## ON-SITE SEWAGE DISPOSAL SYSTEM HOWARD COUNTY HEALTH DEPARTMENT BUREAU OF ENVIRONMENTAL HEALTH

ADDRESS: 12549 Route 216 PROPERTY OWNER: Wilbur Hinkle

| PURPOSE:  | Existing septic system has failed. Call for inspection when ground is opened so sanitarian can recommend repair.  |

SITE INSPECTION SHEET

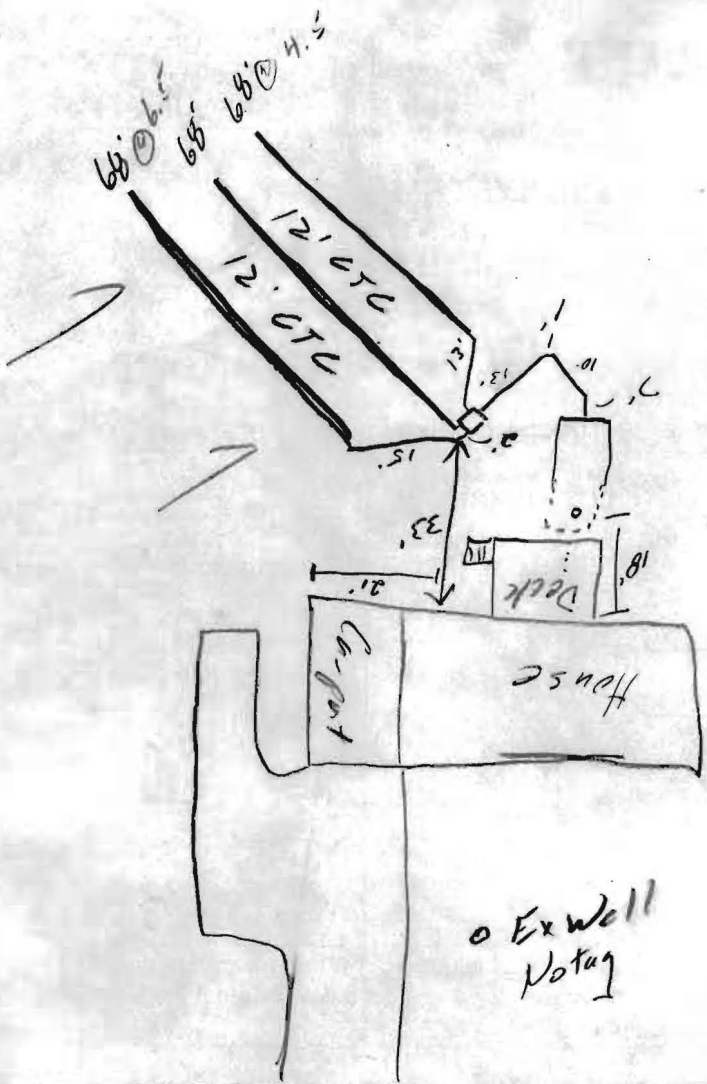
PRE-CONSTRUCTION 7/12/04 - At another layout, contr. asked if I could check insp. an upgrade they had done (SO)

INSTALLATION 7/12/04 - Complete system installed

OK to cover (SO) Drywell collapsed & covered

too (KN/SO)

LOCATION DIAGRAM

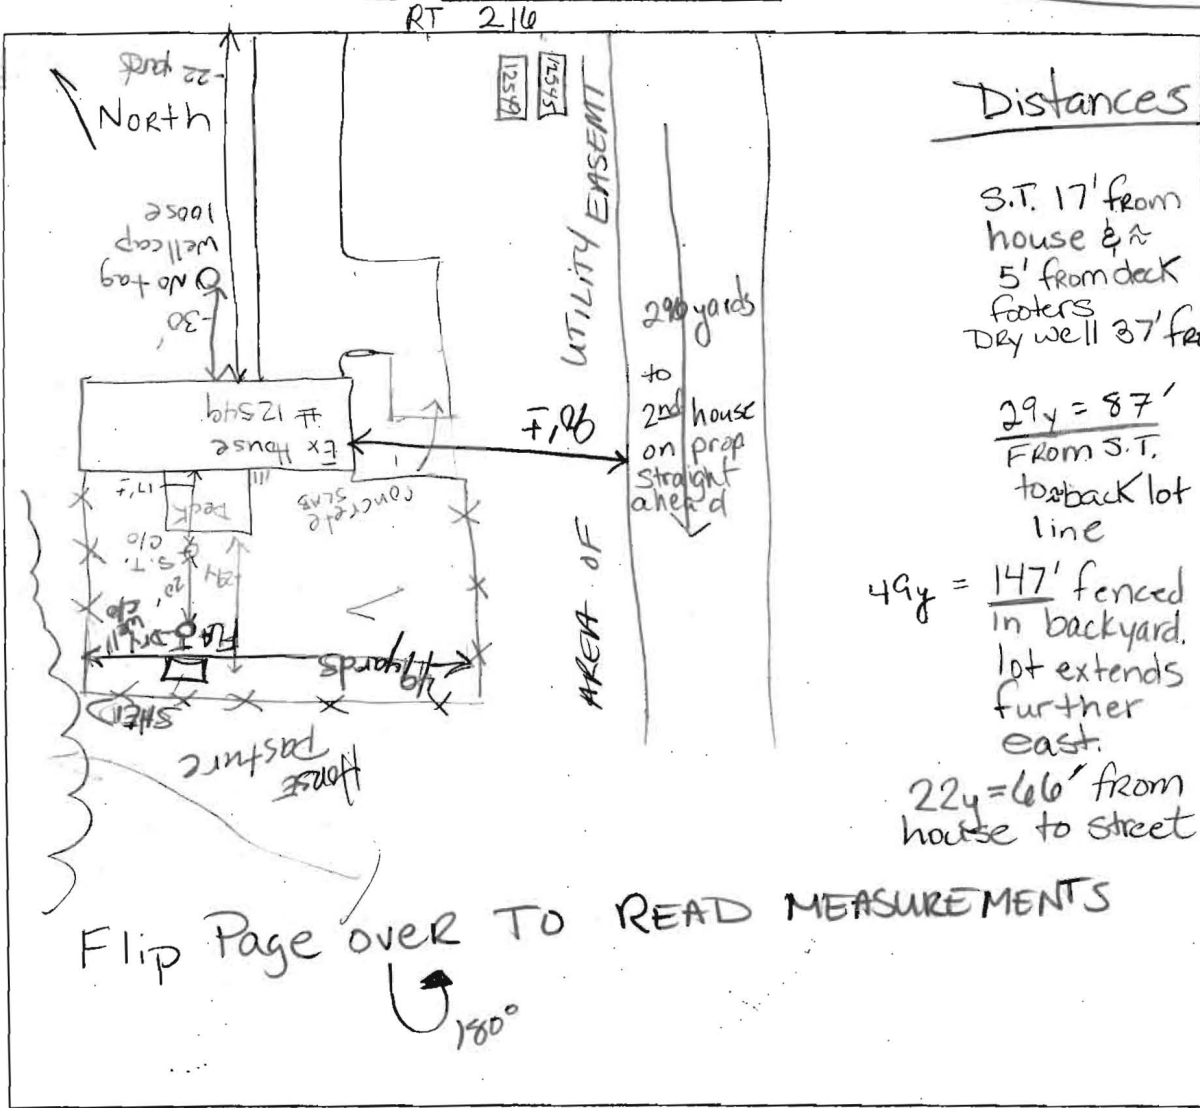
S.T. 17' from house & 5' from deck footers  
Dry well 37' from house

COMMENTS: #12549 S.T. Scum almost up to top of tank. Baffles degraded? Need Repair area identified to support above bp#. Spoke with future (family) Hinkle homeowner about chlorinating ex well, testing the water, & DISCUSSED SEPTIC NEEDS.

Do Not sign permit until septic area & repair are found/done  
KN
